[1] REDLINE REVISION 10/4/03

MARYLAND DOT - STATE HIGHWAY ADMINISTRATION
*Office of Traffic & Safety*
TRAFFIC ENGINEERING DESIGN DIVISION

MD 528 (COASTAL HWY) AND 48TH STREET

| DRAWN BY: | B. THOMPSON | F.A.P. NO. | | TS NO. 1859C | SHEET NO. 1 OF 2 |

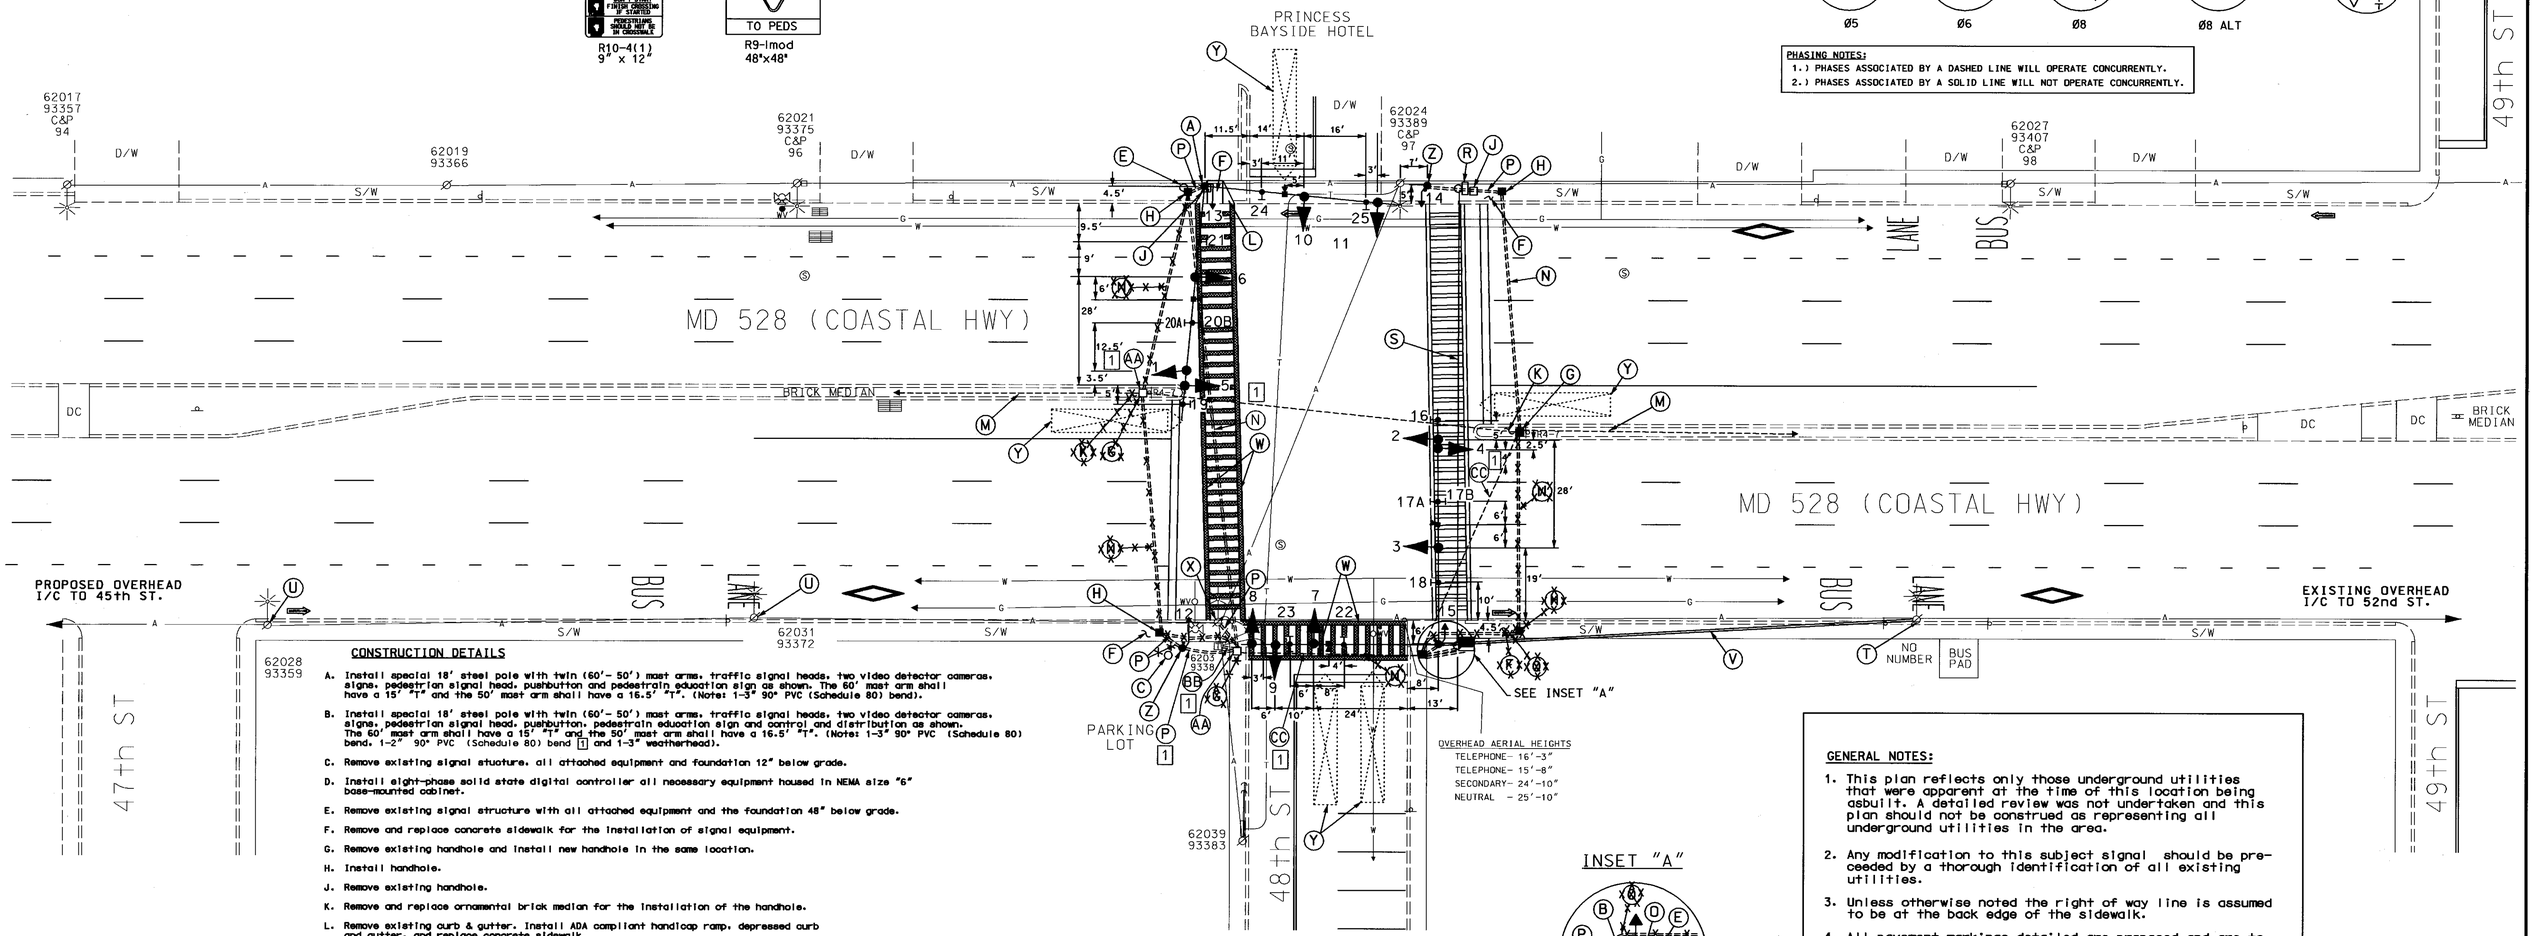
B. Install special 18' steel pole with twin (60'- 50') mast arms, traffic signal heads, two video detector cameras, signs, pedestrian signal head, pushbutton, pedestrain education sign and control and distribution as shown. The 60' mast arm shall have a 15' "T" and the 50' mast arm shall have a 16.5' "T". (Note: 1-3" 90° PVC (Schedule 80) bend, 1-2" 90° PVC (Schedule 80) bend [1] and 1-3" weatherhead).

X. Remove existing I/C cable and span wire. Install 3X 2" [1] polyvinyl chloride (Schedule 80) riser and 3X 2" [1] weather head. Install self-supporting interconnect cable and route thru proposed riser.

[1] AA. Use existing handhole.

[1] BB. Install 1" conduit sleeve to C&P Pedestal.

[1] CC. Use existing conduit.
